DESIGN, SUPPLY, CONSTRUCTION, INSTALLATION, TESTING AND COMMISSIONING OF 2X25kV AC ELECTRIFICATION, SIGNALLING & TELECOMMUNICATION, E&M AND ASSOCIATED WORKS ON DESIGN BUILD LUMP SUM BASIS OF SAHNEWAL – PILKHANI SECTION (APPROXIMATELY 175 ROUTE KM OF SINGLE LINE) OF EASTERN DEDICATED FREIGHT CORRIDOR

SYSTEMS WORKS CONTRACT PACKAGE 304

RESPONSES TO PRE-BID QUERIES OF THE BIDDERS

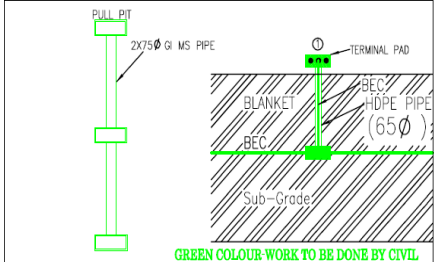
508.	PS Vol2 Electrification 6.5 Page 491 Table 6.5.1 Design short circuit levels for 132kV, 220kV	Based on MVA levels provided, Calculated fault level for 220kV is 52.48 kA & for 132 kV is 43.74 kA. Generally 220kV equipment's are available with 40kA for 1 sec short circuits withstand capability and for 132kV equipment's it would be 31.5kA & 40kA for 1 sec short circuit capability.	The Provisions of the bidding document shall prevail.

Sr No.	Reference to Bid Document	Clarification Sought by the Bidders	DFCCIL's Response
(1)	(2)	(3)	(4)
		Please confirm the short circuit level of the equipment?
